HISTORIC AND DESIGN REVIEW COMMISSION

HDRC CASE NO: 2014-287
ADDRESS: 602 Roosevelt
LEGAL DESCRIPTION: NCB 3122 (LALJI SUBD), BLOCK 3 LOT 12
ZONING: C2 MC-1 RIO-4
CITY COUNCIL DIST.: 5
DISTRICT: RIO-4
APPLICANT: Bradley Bechtol
OWNER: Price Companies
TYPE OF WORK: New Construction of Townhomes

602 Roosevelt Avenue Townhomes

Site Plan

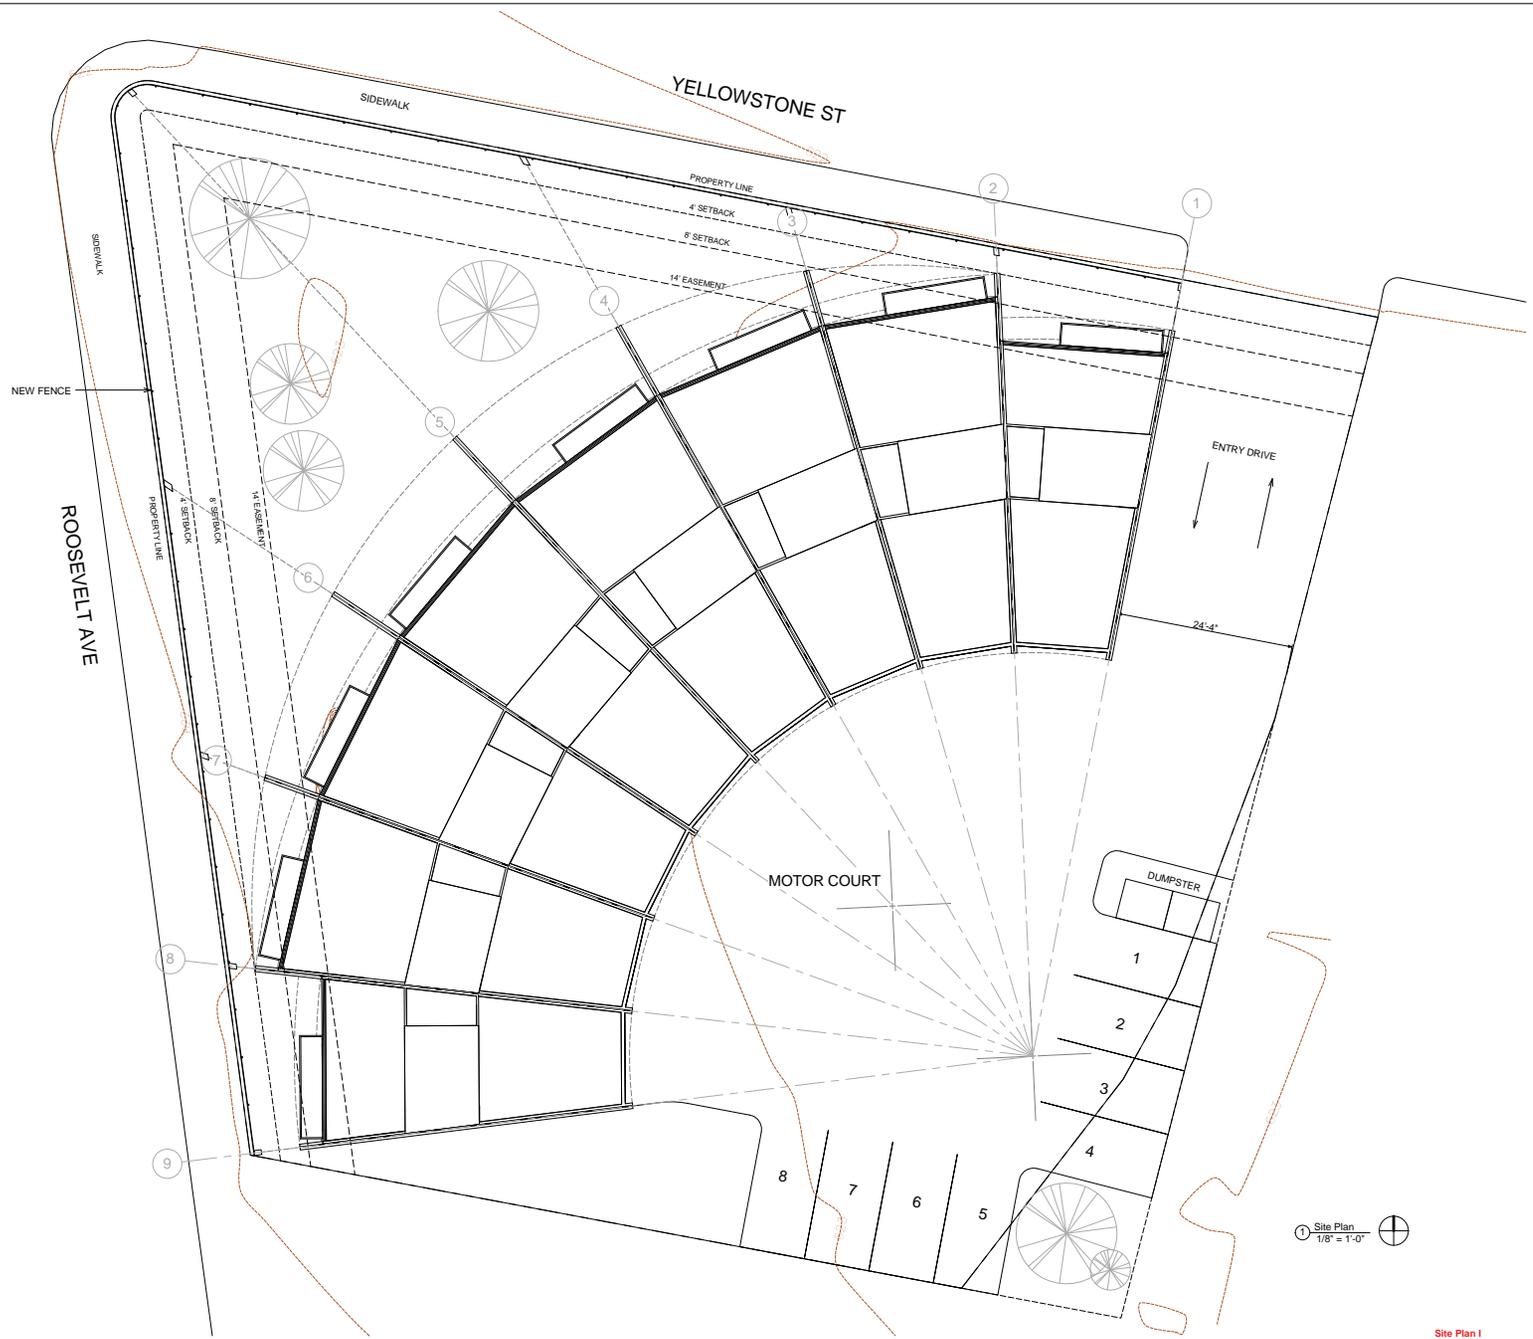
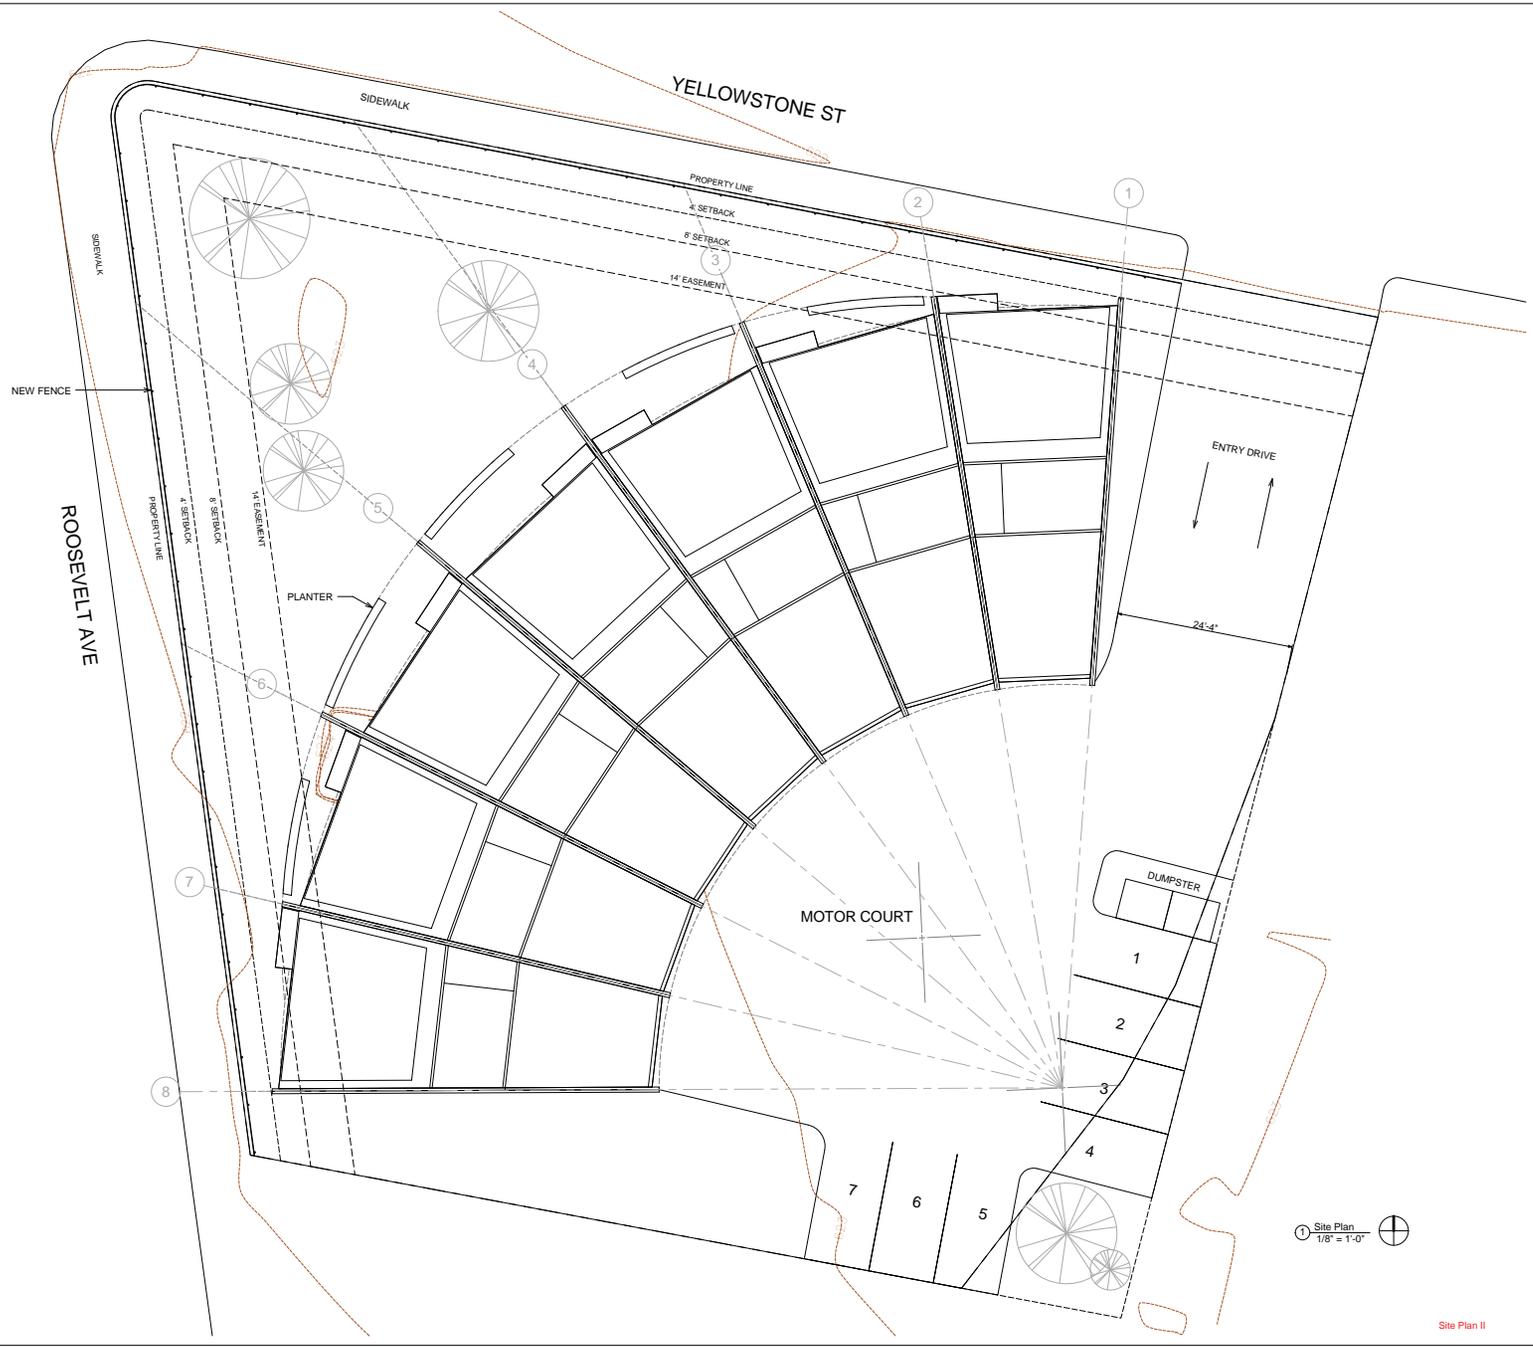
- b. The proposed parking area for this development is located at the rear of the property and is consistent with UDC Section 35-671(b).
- c. This area along Roosevelt consists of a mix of commercial, industrial and residential uses. The proposed scale of the development is appropriate within the context of the adjacent residential neighborhood consistent with UDC Section 35-674(a).
